A D D E N D U M

PROJECT TITLE: PUBLIC SPACE AT MARKET SLIP & HARBOUR PASSAGE EXTENSION	ADD. NO: 4	
TENDER NO: 2022-081201T	DATE: July 15 th , 2022	
PAGE 1 of 2 (Including Confirmation Sheet)

ASK10

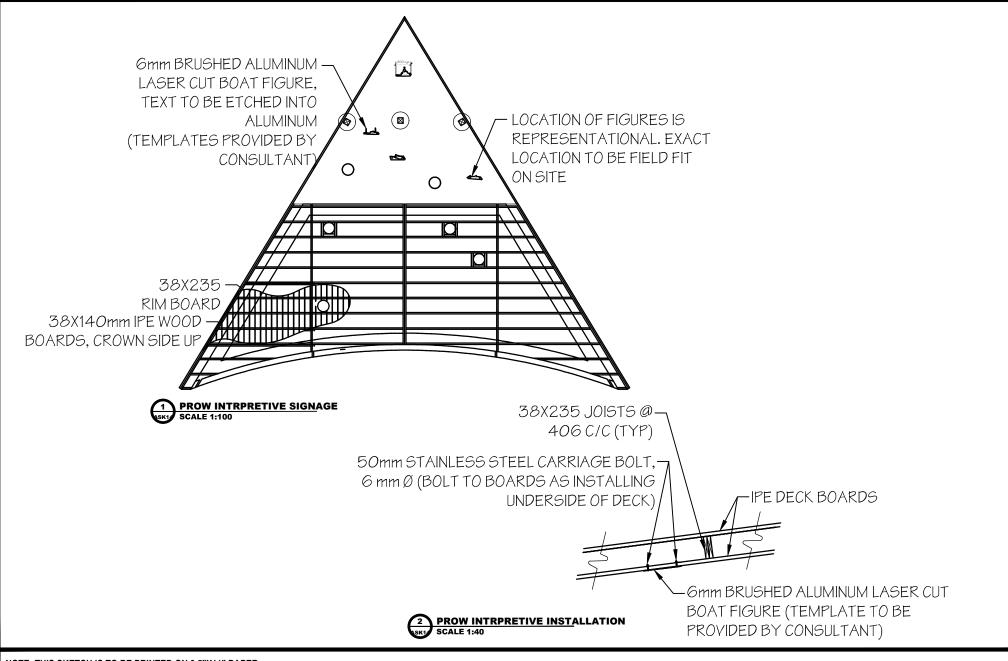
Missing Drawing from Addendum #3.

I noticed on addendum (3 3) on line #2 the drawing ASK10 was referenced. Was it supposed to be attached to this addendum?
